Re: Sid Cutter Pilot's Pavilion, Conceptual Grading and Drainage Plan Engineer's Stamp Date –no stamp- (B17D001F)

Based upon the information provided in your submittal received 5-9-14, the above referenced plan is approved for Site Plan for Building Permit action by the DRB.

BALLOON FIESTA PARK SID CUTTER PILOTS' PAVILION

SITE DEVELOPMENT PLAN FOR BUILDING PERMIT CONCEPTUAL GRADING & DRAINAGE PLAN

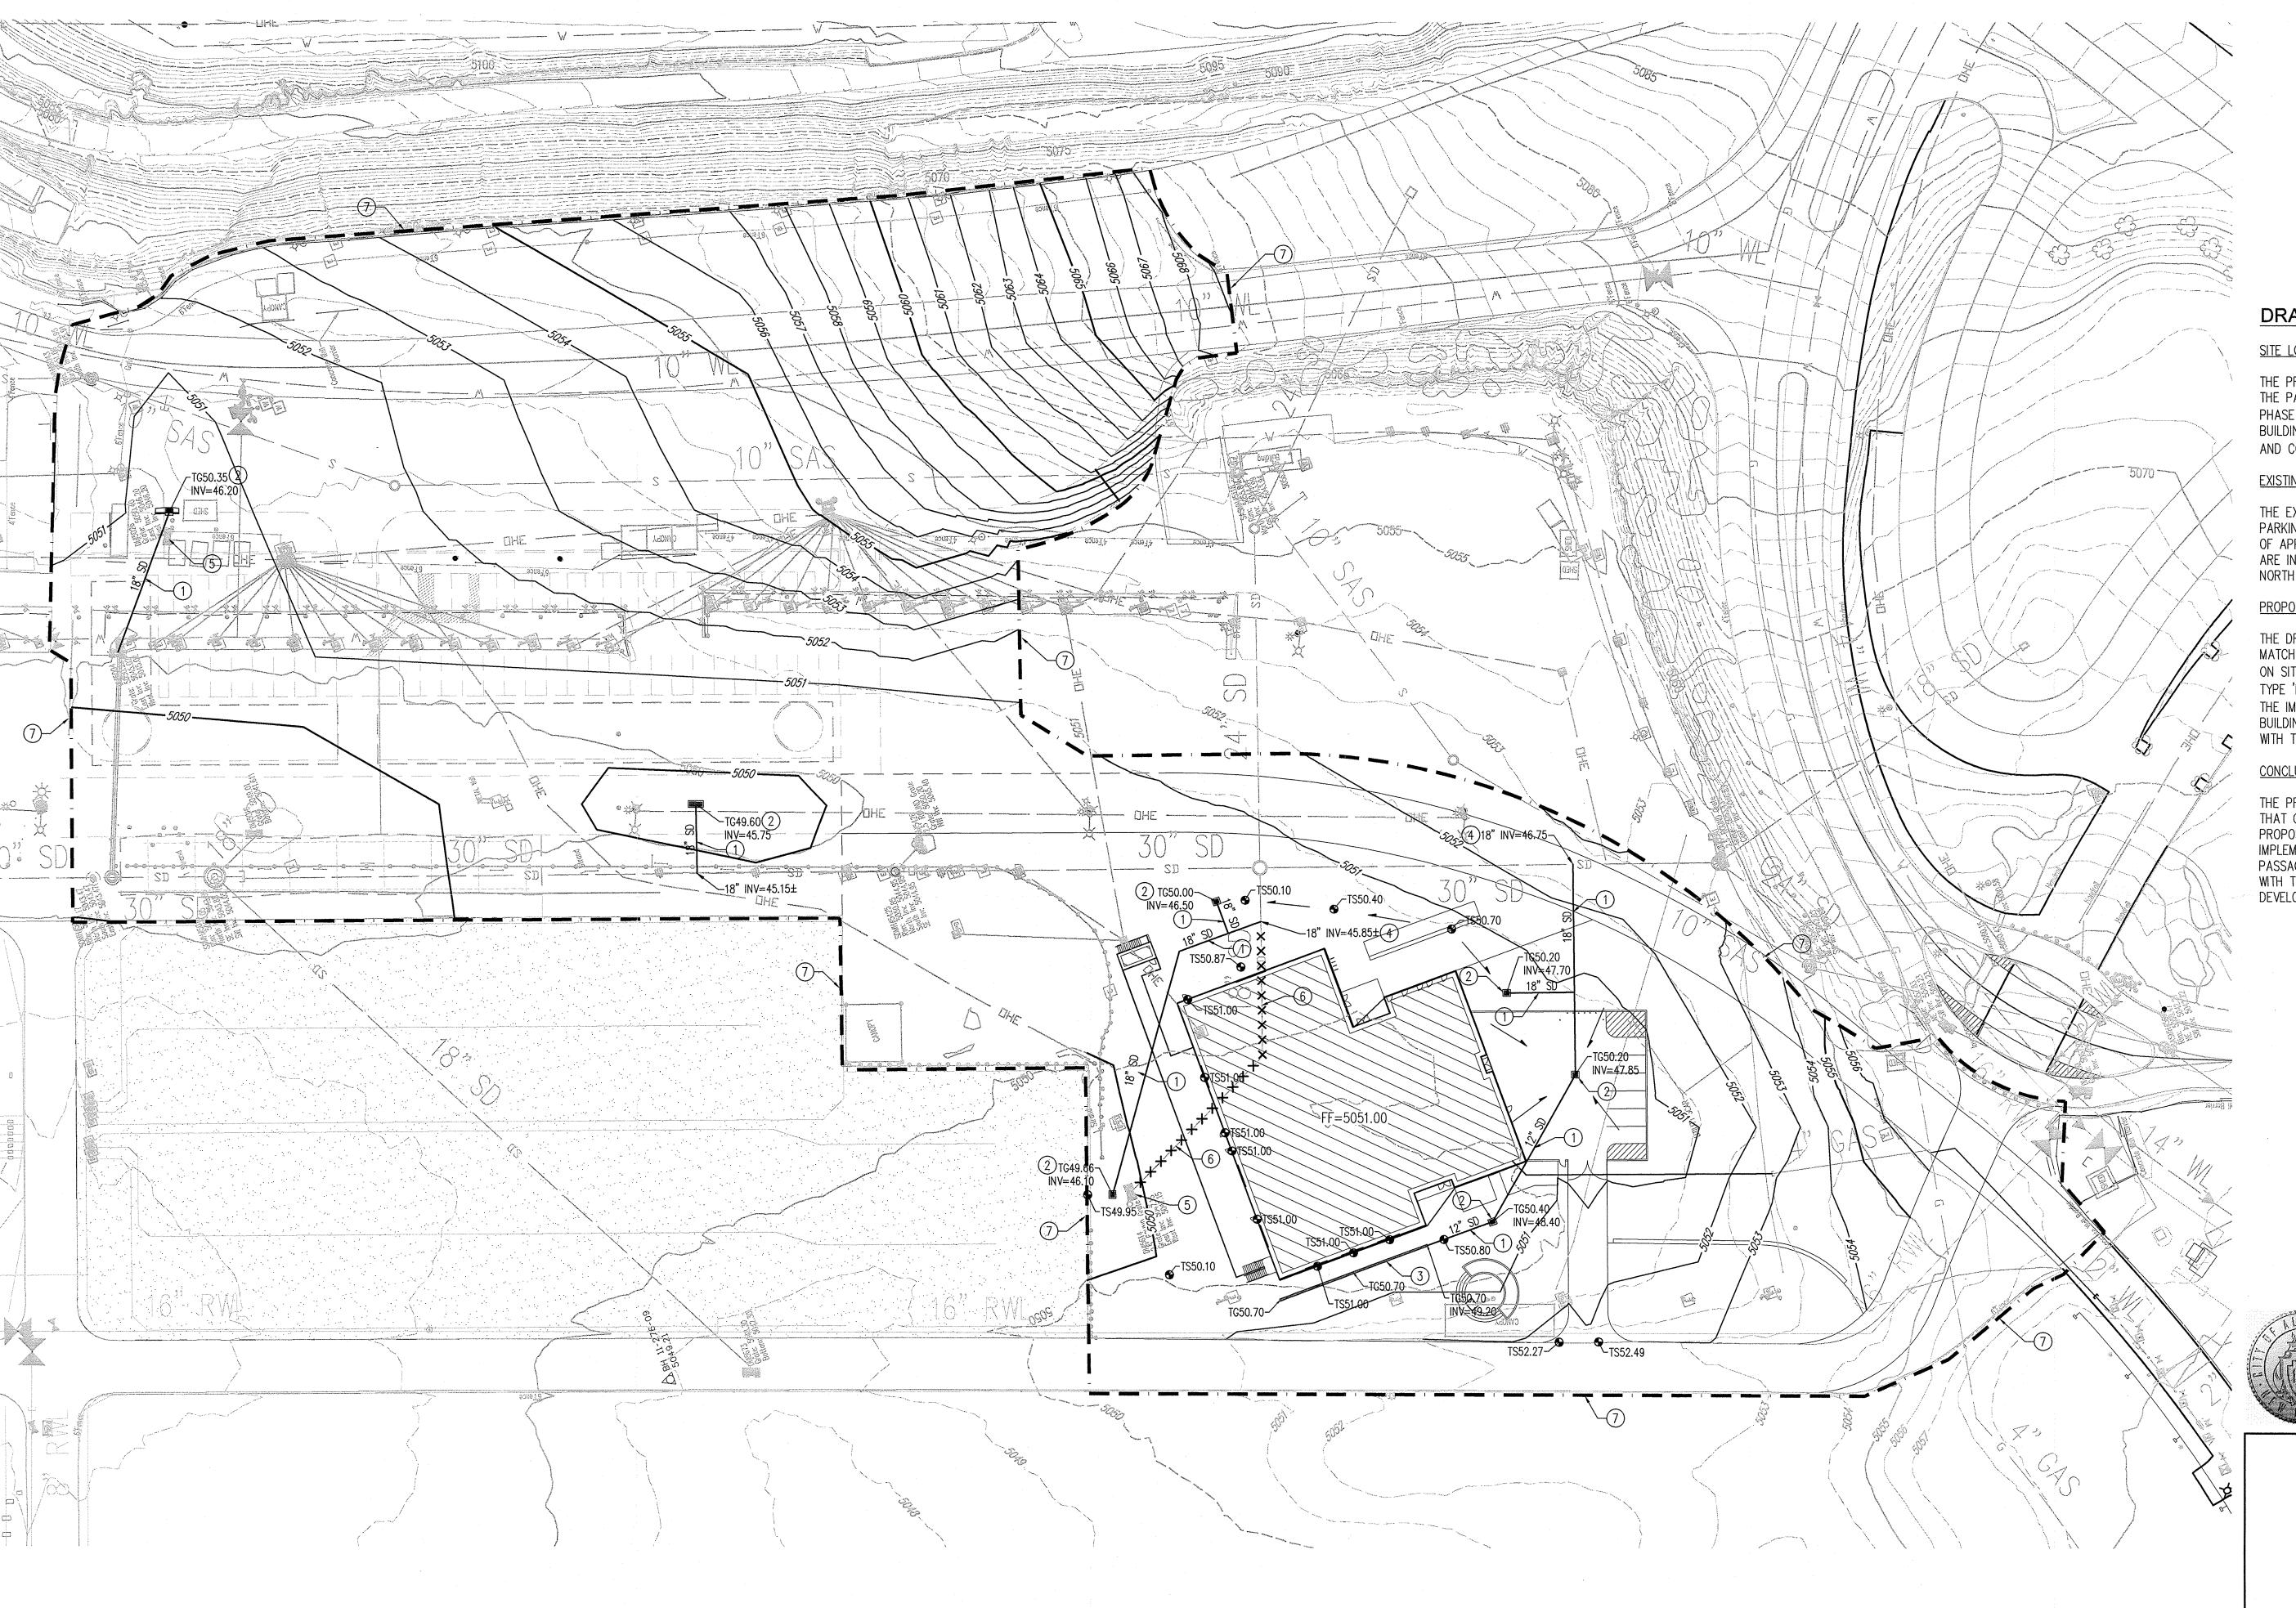
1. Manholes will be required when making the 90 degree connection for two of the new storm drains. A manhole or elbow will be required for making the 45 degree connection.

- 2. How will the furthest north connection be made? Is a collar required?
- 3. Specify storm drain material.
- 4. What does the hatching represent in the median south of the building?
